Request by William Montelbano for renovation project approval at Fosdal's Baker, 243 E. Main Street.

Approving a Renovation Project for Fosdal's Bakery, 243 E. Main Street, Stoughton, WI.

Fosdal Bakery Remodel
Project

PROPOSED NORTH ELEVATION
SCALE: 1/8"=1'-0"

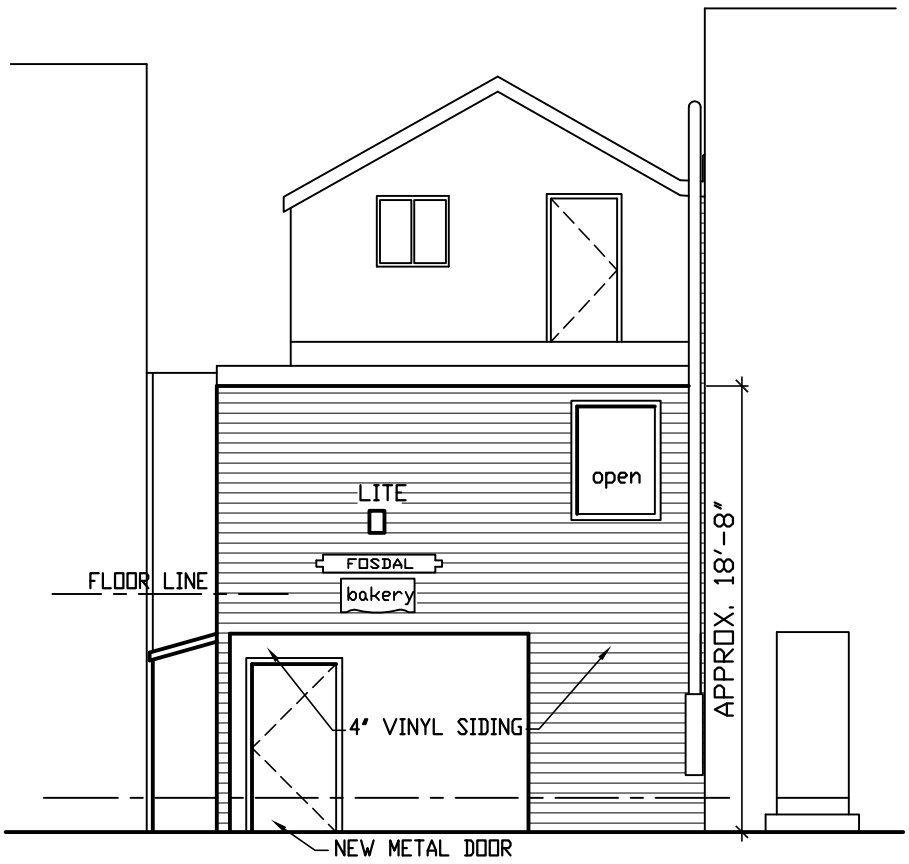
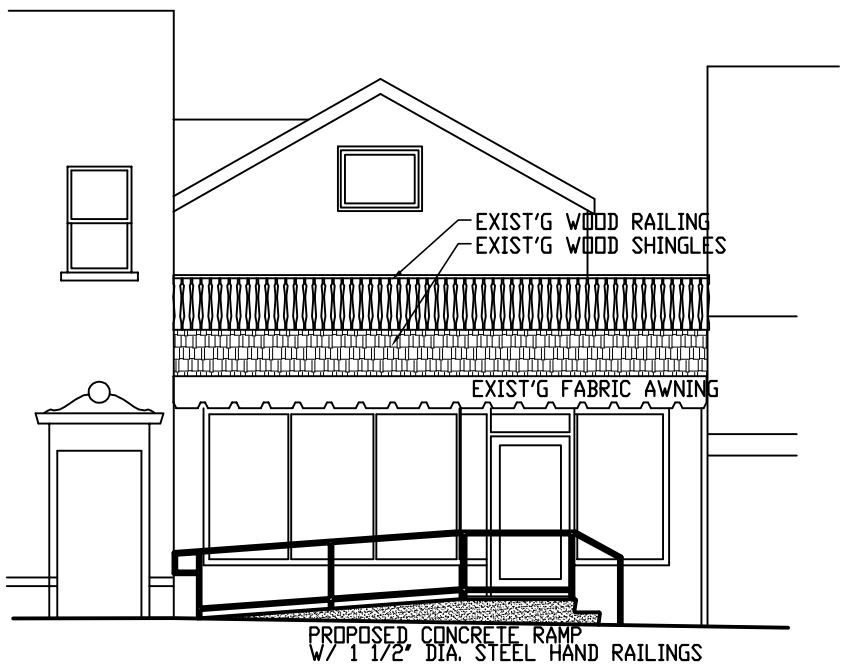
d. *Horizontal Bands.* Wherever possible, existing horizontal bands (such as storefront cornice or lintel and transom windows) shall be retained and uncovered; owners shall move or remove large signs that may cover the banding to allow the horizontal elements to be expressed. When horizontal rhythms are found, horizontal elements that also exist in buildings to either side of the subject building shall be retained. Existing transom windows shall not be filled with brick, wood or other materials. If original building design called for transom windows that are now missing, they shall be visually recreated. If the storefront cornice or lintel is missing, a horizontal division shall be achieved by replacing or simulating the cornice and/or incorporating it in the sign board. **The existing storefront is not changing except the accessibility ramp and handrails.**

PROPOSED WEST ELEVATION

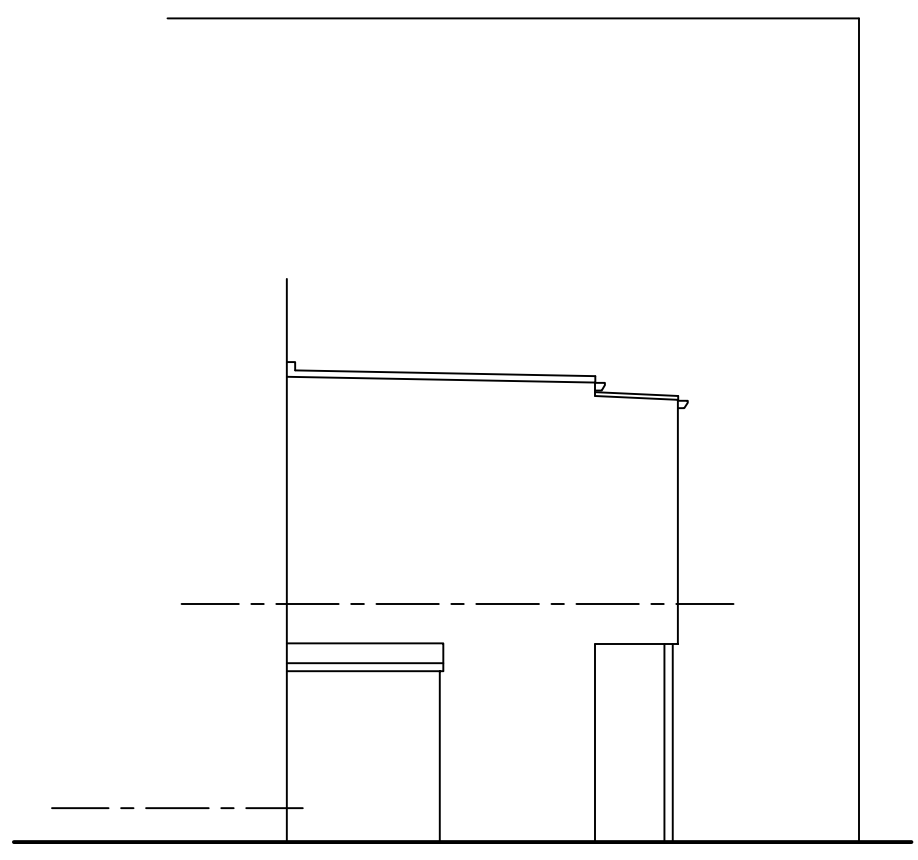
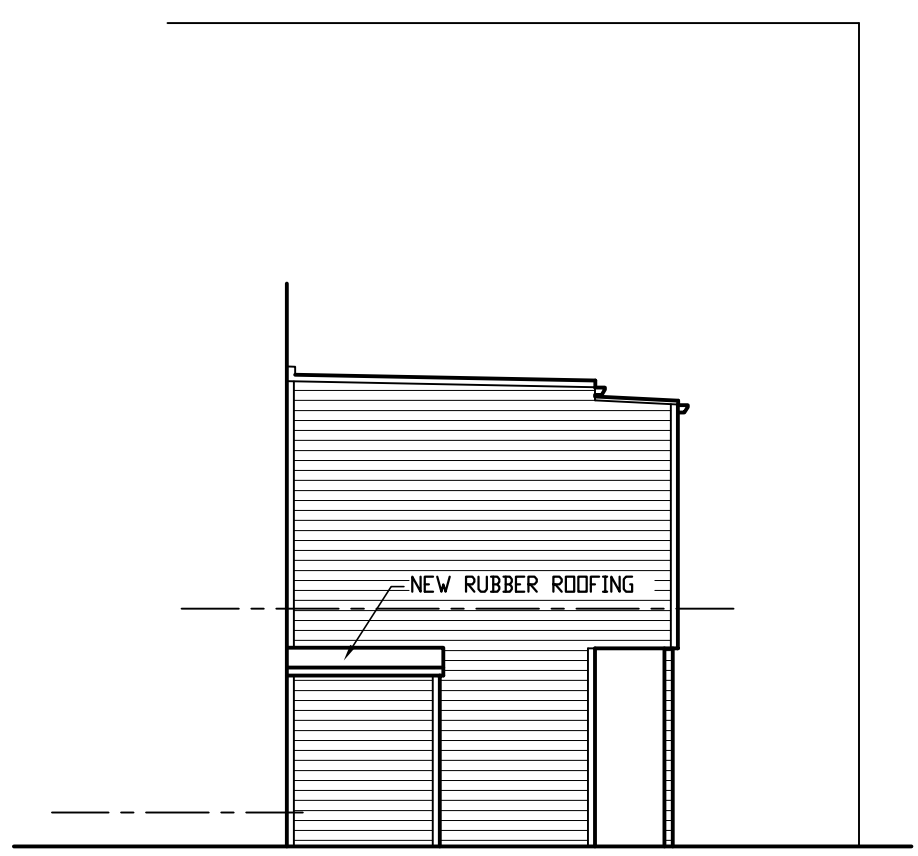
i. *Exterior Materials.* In any renovation work, preserving the downtown quality and character shall be given the highest priority. Therefore, to protect the distinctive quality and character of an existing building, any new materials used shall match as closely as possible either the existing materials or the materials used at the time the building was originally constructed. When the cost or availability of materials that match original materials make their use prohibitive, and when alternate materials can visually match original materials, the use of alternate materials shall be permitted. The uniform identity created by the repeated use of masonry as the primary building material is very important to retain. As a rule, new buildings shall be constructed with street-facing facades of brick or stone. If the majority of street-facing facades within the block-face are constructed with siding (see below), then siding shall be permitted. On a site-specific basis, the trim materials of existing buildings to either side of the building being designed shall be reflected in the design. In addition:

2. *Siding.* Wood or thin board textured vinyl or textured metal clapboard siding may be appropriate, particularly if the proposed non-masonry exterior was originally used on the building. In certain instances, clapboard or board and batten may be in keeping with the general design theme. Asphalt shingle siding, rough-sawn shake siding or diagonal wood siding shall not be permitted.

To be reviewed by the Plan Commission.
